Work Order ID 72418

Item Name: Crosstube Aft

DART AEROSPACE LTD		Work Order:	72418
Description: Crosstube High Aft (205/212)		Part Number:	D212-664-201
Inspection Dwg: D212-664-241 Rev: D		Page 1 of 1

DRAWING NO. D212-664-241	TITLE CROSSTUBE ASSY (205/212 HI AFT)	REV. D	DART AEROSPACE LTD ENGINEERING ORDER		D.E.O. NO. D212-664-241-D-1	SHEET NO. SHEET 1 OF 2	SCALE NTS
DRAWN	CHECKED	MFG. APPR.	APPROVED	DE APPR.			
DATE 11.04.07	DATE 11.04.11	DATE 11.04.12	DATE 11/04/12	DATE 11.04.12

**D212-664-241/-241B
ASSEMBLY DETAIL**

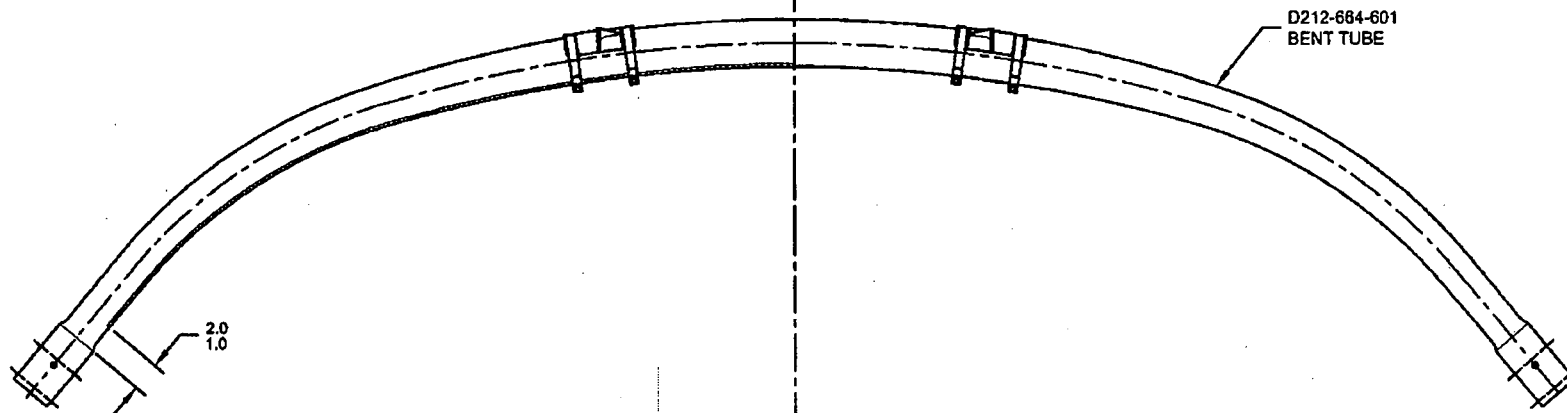
PURPOSE:

ADD AN INSPECTION WINDOW TO UNDERSIDE OF CROSSTUBE.

NOTES 2 OF SHEET 1 IS AMENDED AS FOLLOWS:

- 2) FINISH: CHEMICAL CONVERSION COAT PER DART QSI 005 4.1
PRIME INSIDE AND OUTSIDE PER DART QSI 005 4.2
MASK UNDERSIDE OF CROSSTUBE AS SHOWN (HATCHED AREA) AND
PAINT OUTSIDE PER DART QSI 005 4.2
REMOVE MASKING AND APPLY CLEAR COAT

- 2) FINISH: CHEMICAL CONVERSION COAT PER DART QSI 005 4.1
PRIME INSIDE AND OUTSIDE PER DART QSI 005 4.2
PAINT OUTSIDE PER DART QSI 005 4.2

MASK AREA PRIOR TO PAINTING,
REMOVE MASKING AFTER PAINT
AND APPLY CLEAR COAT
